University of South Carolina

Project Name: UTS MOD Closet Electrical Upgrades - Various Buildings

Addendum Number Two

From: Belka Engineering Associates, Inc.

Drawing E1 –

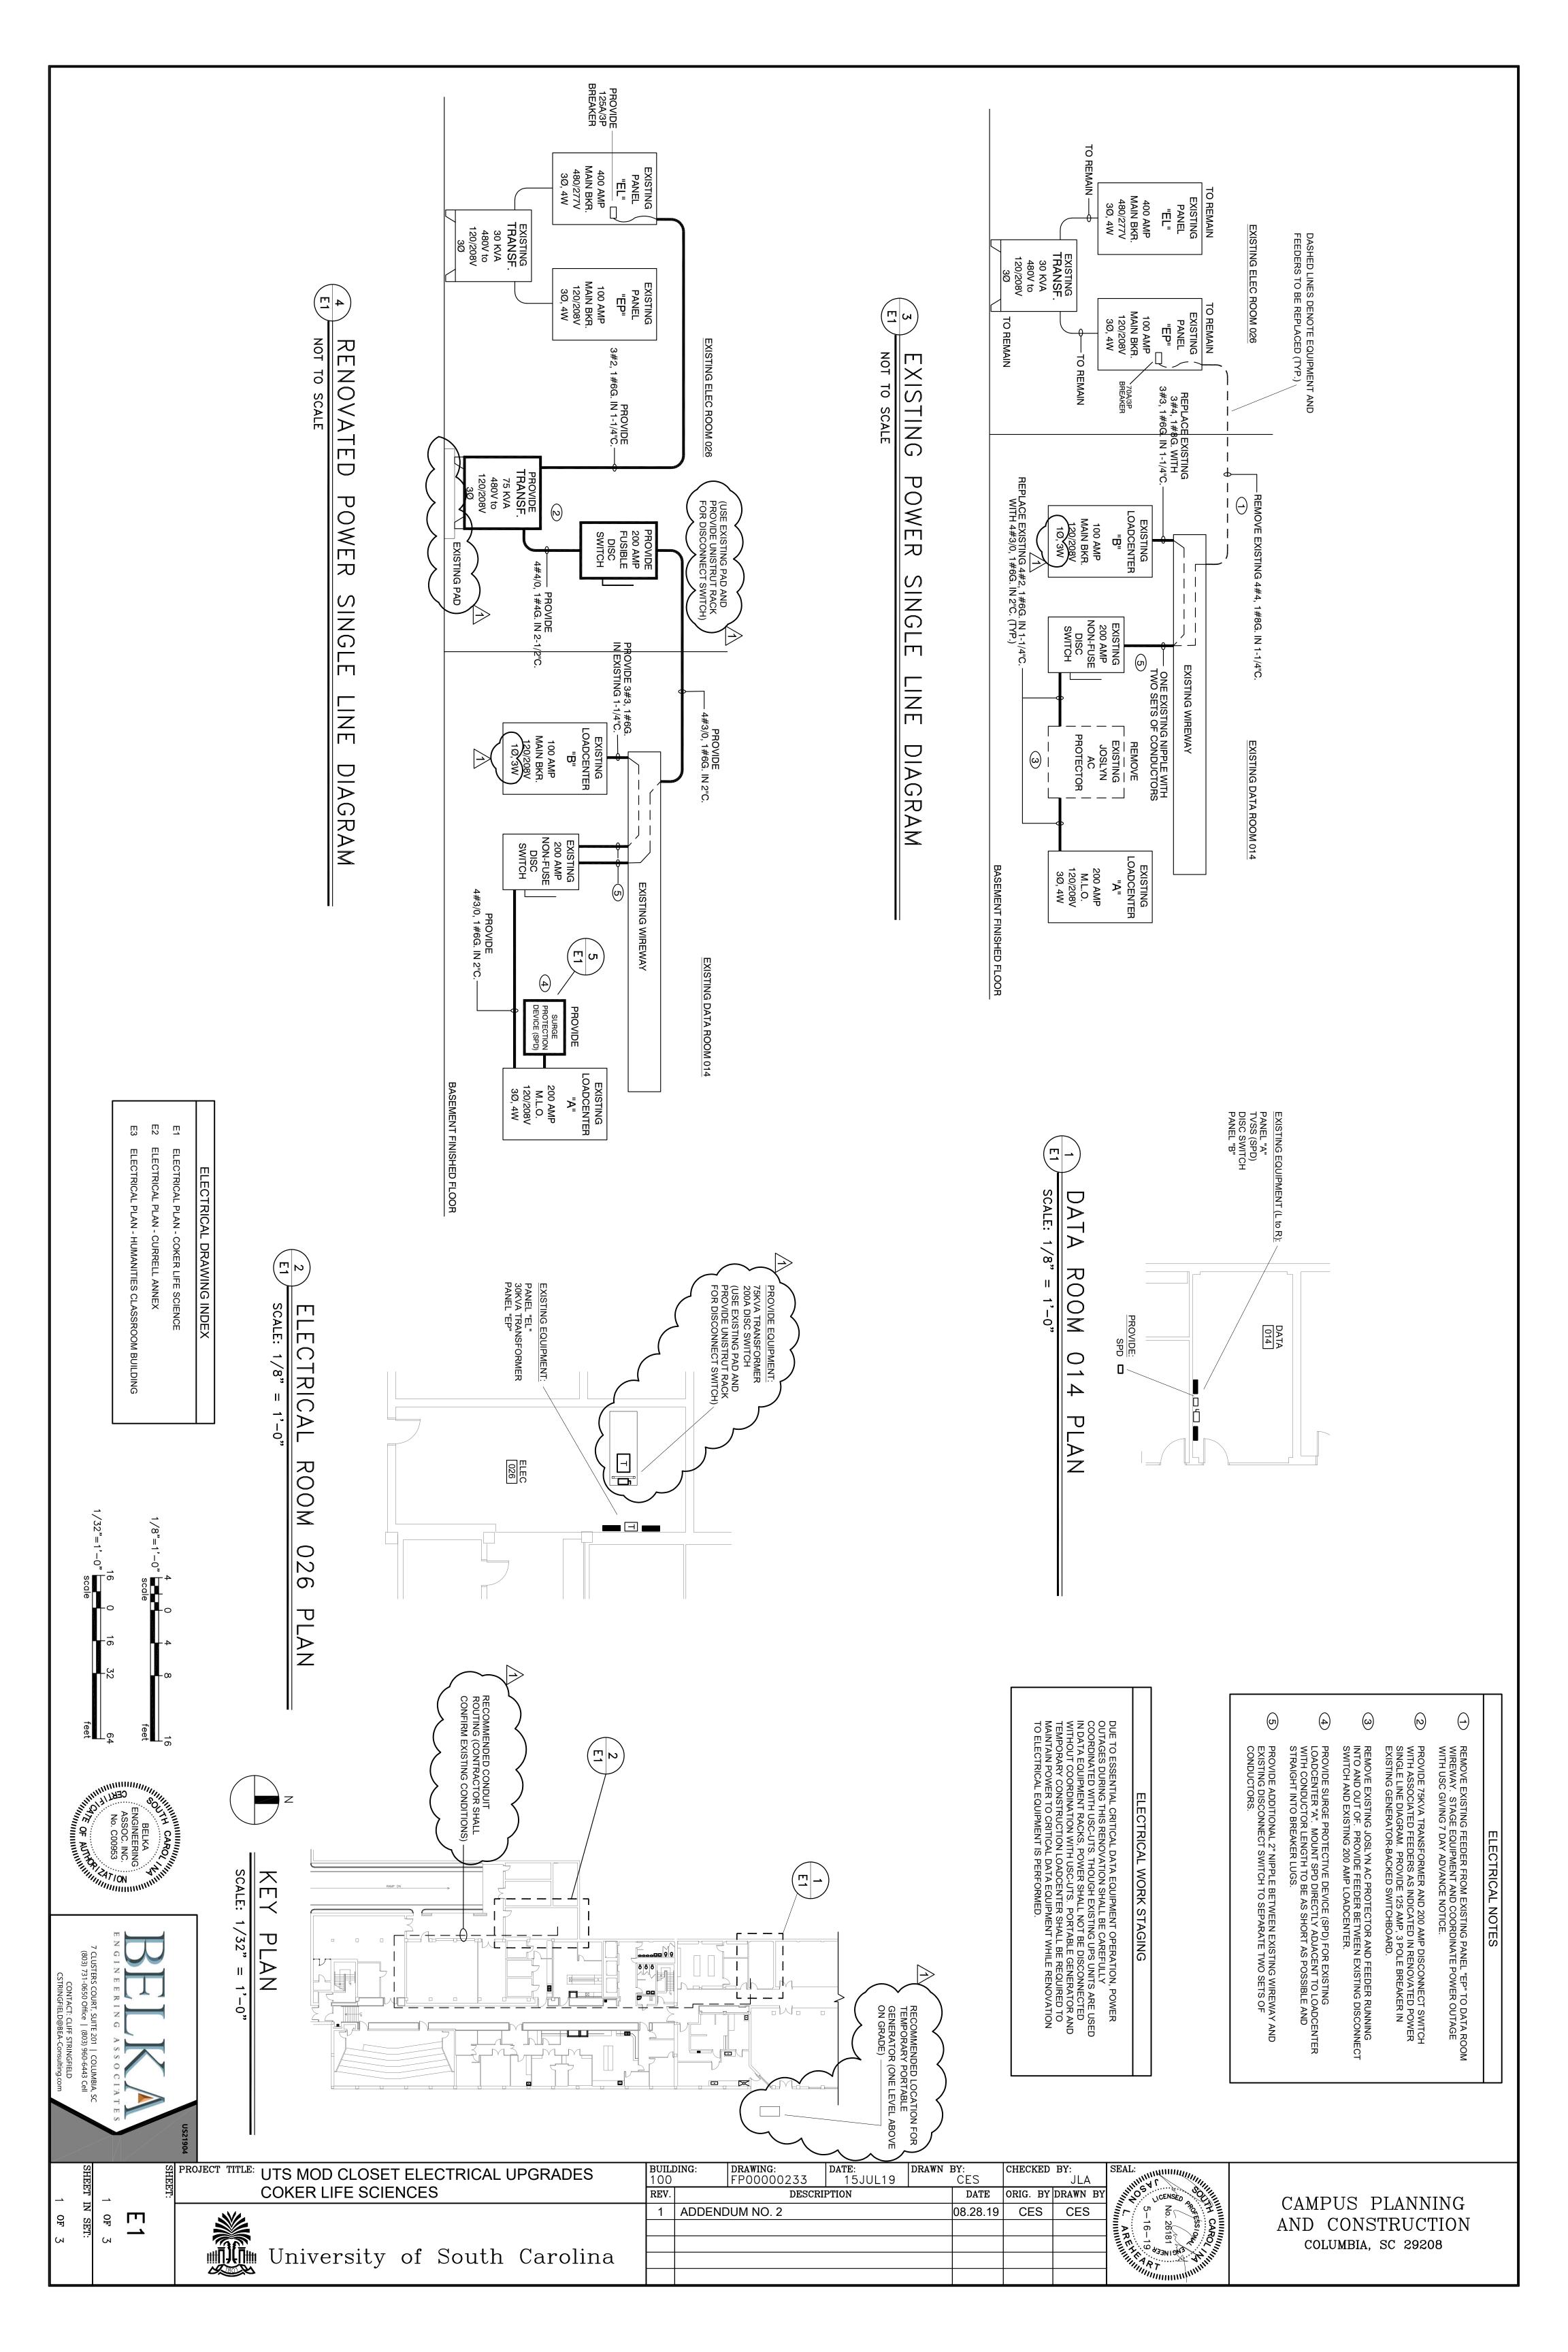
- 3. Q: In the existing main electrical room at Coker, the space above existing panels is limited with existing HVAC piping. How will new electrical conduits be run? A: Wall penetrations may be made below existing HVAC piping and surface conduit be wall mounted. An alternate suggested conduit routing is shown on attached revised drawing E1.

- 1. In both Single Line Diagrams, change Existing Loadcenter "B" to single phase, 3 wire in lieu of 3 phase, 4 wire.
- 2. In both Single Line Diagrams, change the feeder for Existing Loadcenter "B" to 3#3, 1#6G. in existing 1-1/4"C. in lieu of 4#3, 1#6G.
- 3. In Renovated Power Single Line Diagram, add note adjacent to "Provide 75kva transformer" that reads, "Use existing concrete housekeeping pad in center of room for this transformer. Secure to transformer to floor." See attached drawing E1.
- 4. In Renovated Power Single Line Diagram, add note adjacent to "Provide 200 amp disconnect switch" that reads, "Mount switch on Unistrut rack adjacent to transformer."

Drawing E3 –

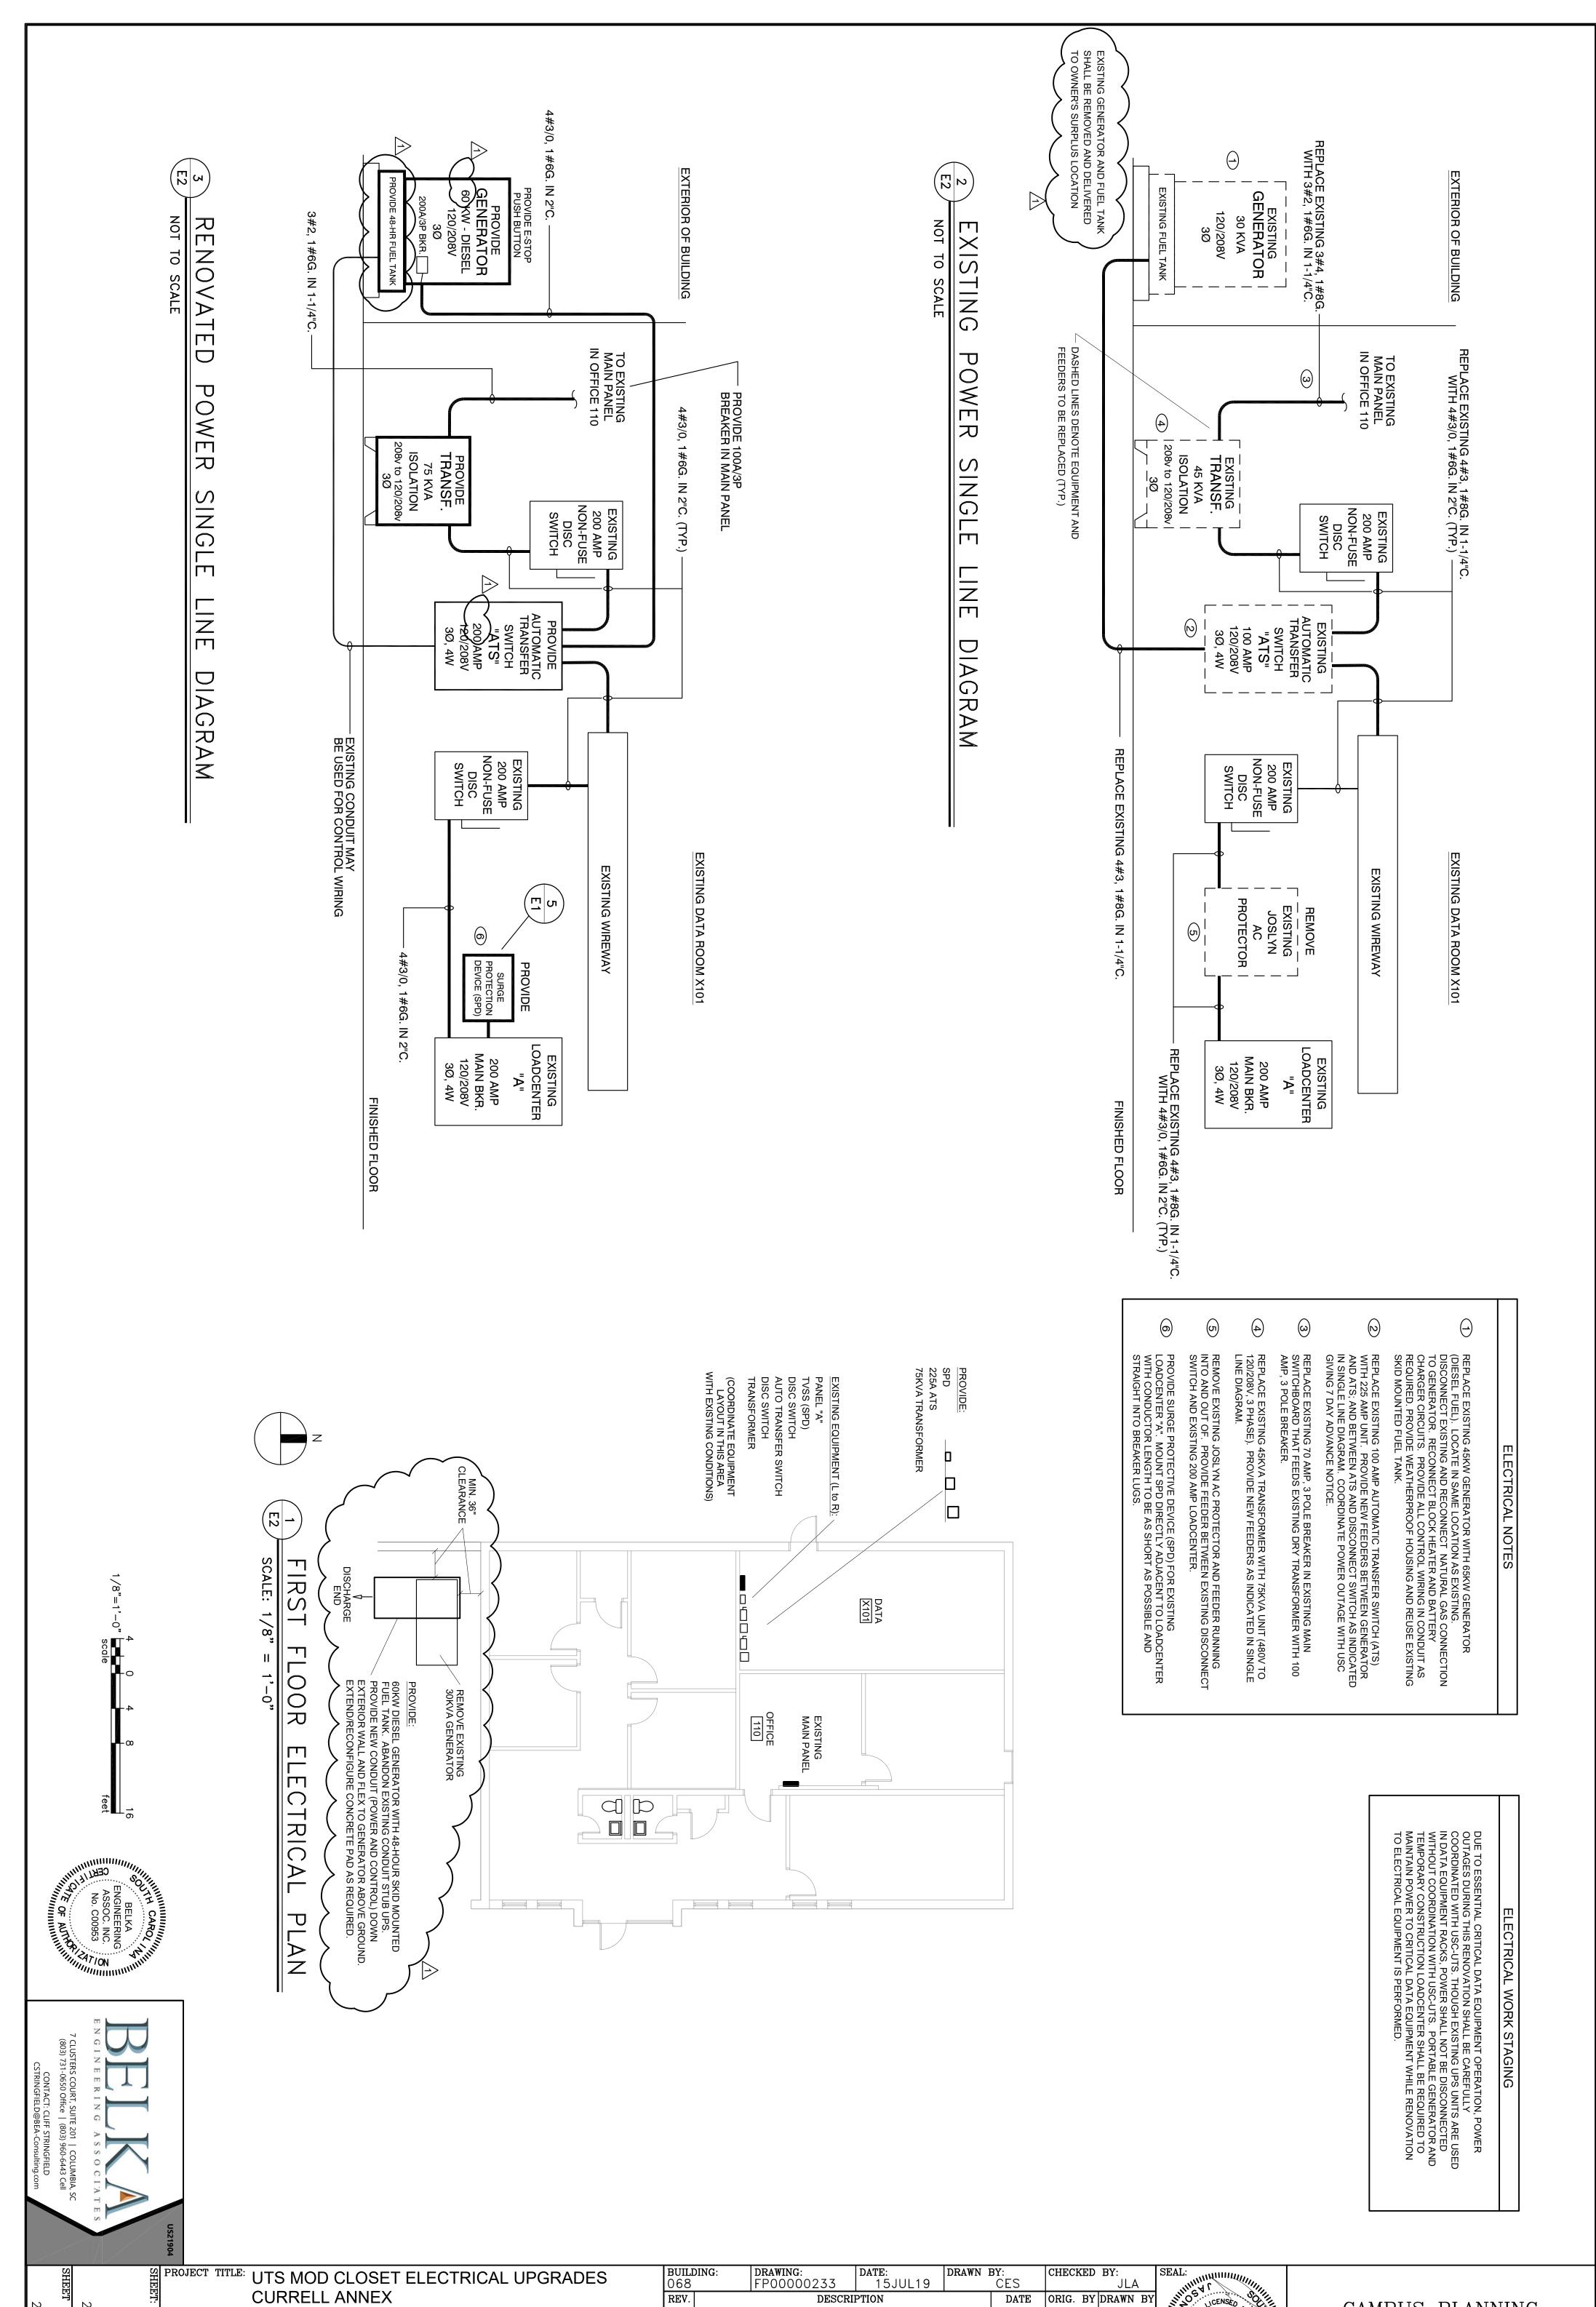
- 9. In In both Single Line Diagrams, change Existing Loadcenter "B" to single phase, 3 wire in lieu of 3 phase, 4 wire.
- 10. In both Single Line Diagrams, change the feeder for Existing Loadcenter "B" to 3#3, 1#6G. in existing 1-1/4"C. in lieu of 4#3, 1#6G.
- 11. In both Single Line Diagrams, add existing 100 amp disconnect switch ahead of transformer.

12. In Renovated Power Single Line Diagram, provide a 90-amp, 3 pole breaker in existing main generator-backed panel and conductors/conduits as shown on attached revised drawing E3.
